ADDENDUM NO. 2

TO: REQUEST FOR QUALIFICATIONS FOR STATE OF MISSOURI:

**Design/Build Services
New Administrative Offices and Fleet Garage
Office of Administration, Division of General Services
Jefferson City, Missouri
PROJECT NO.: O2548-01**

SHEET TITLE:
SITE PLAN

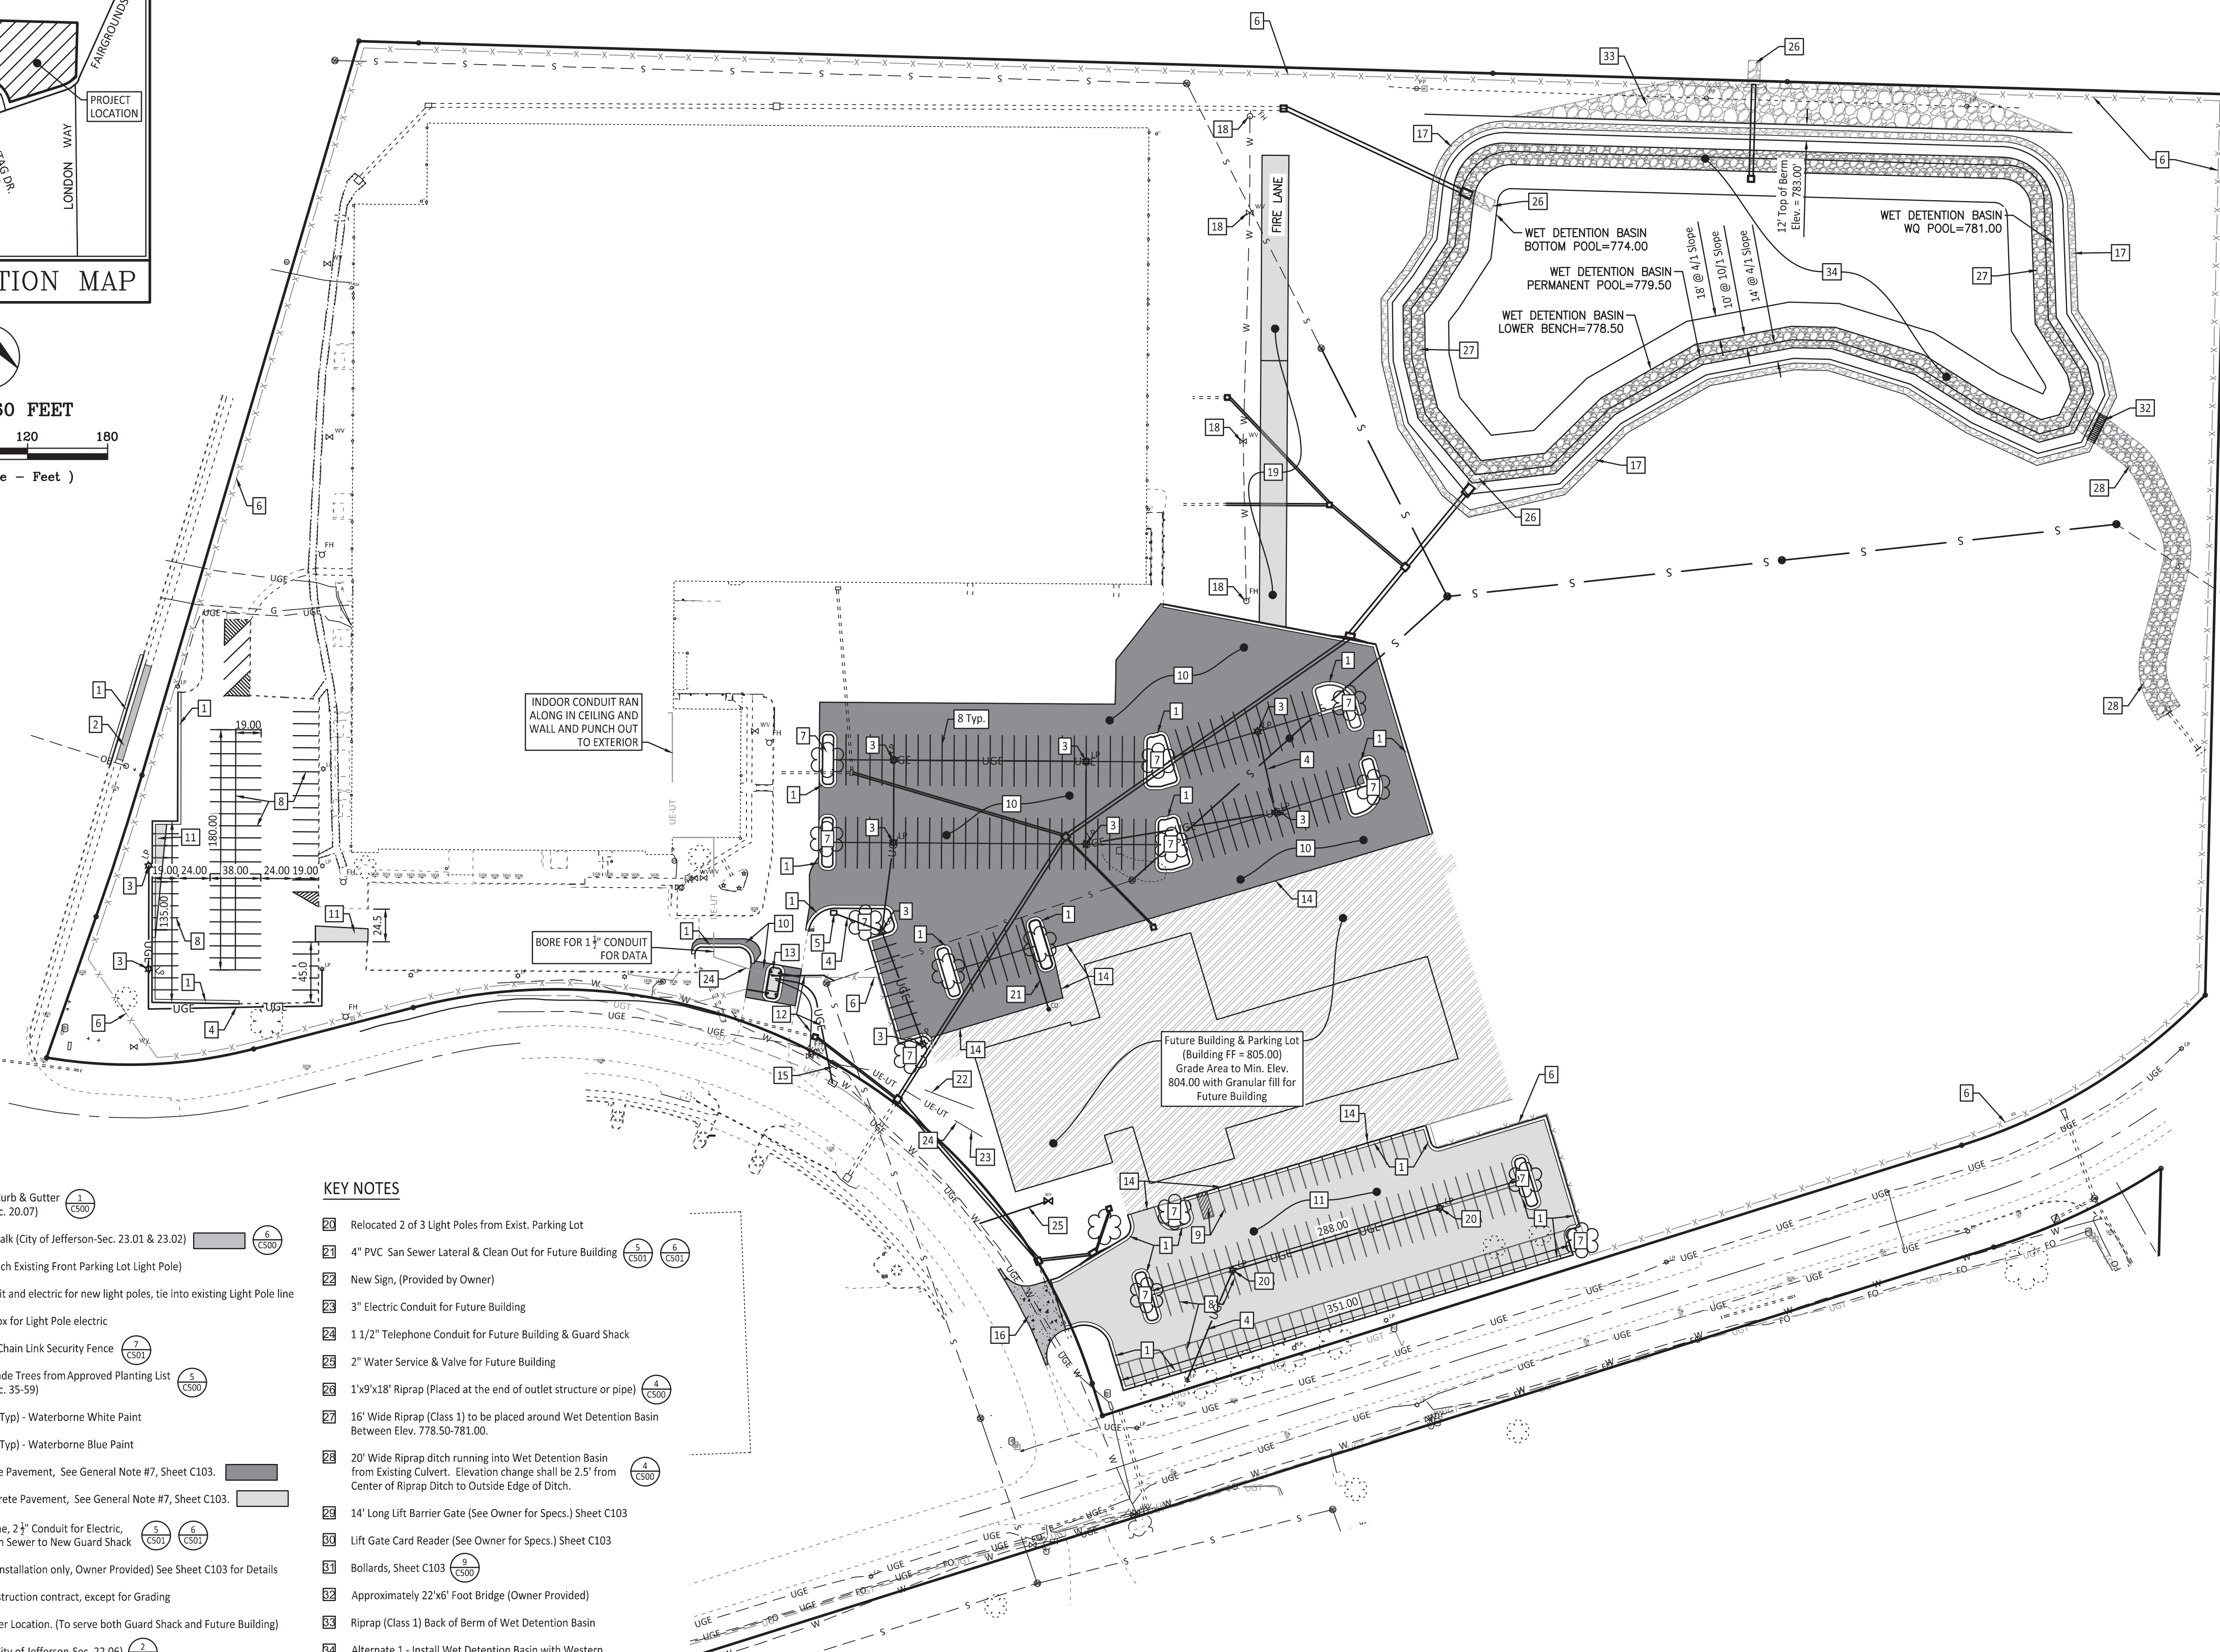
This project will have a site ready building pad, with existing parking lots. Storm sewer, sanitary sewer, water, electric and communications are stubbed up near the building pad. Limited sitework, such as connecting utility stubs to building, providing the transformer, walkway and driveway connections to parking will be required. See attached site plan for parking lots being constructed in another project that is near completion. Please note the building outline on this plan was a preliminary study and will be subject to bidder's design.
